**Advisory Action  
Before the Filing of an Appeal Brief**

10/687,481

WANG ET AL.

FIG. 8

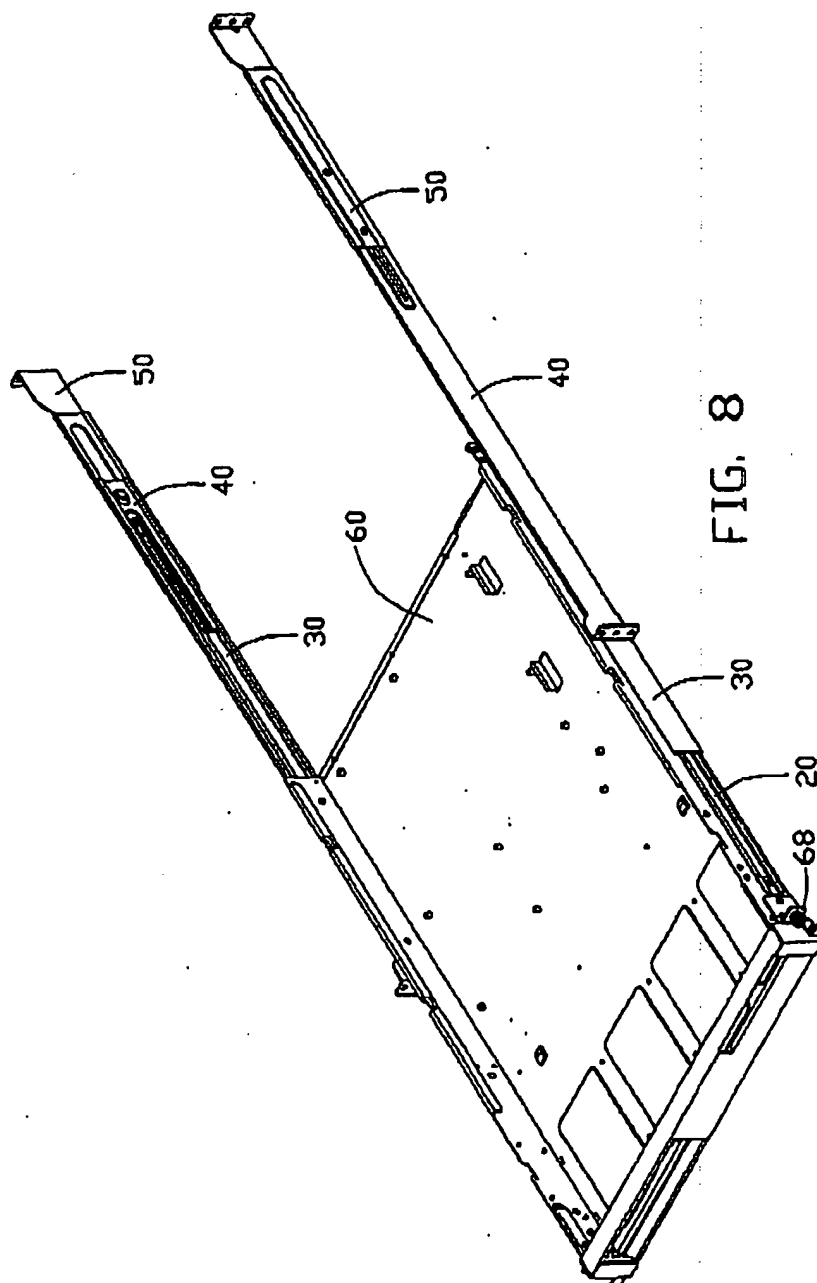
Continuation of 13. Other: The amendment to the drawing and specification if submitted in a seperate, timely filed amendment would be entered and would correct the drawing objection to the fixing ear.
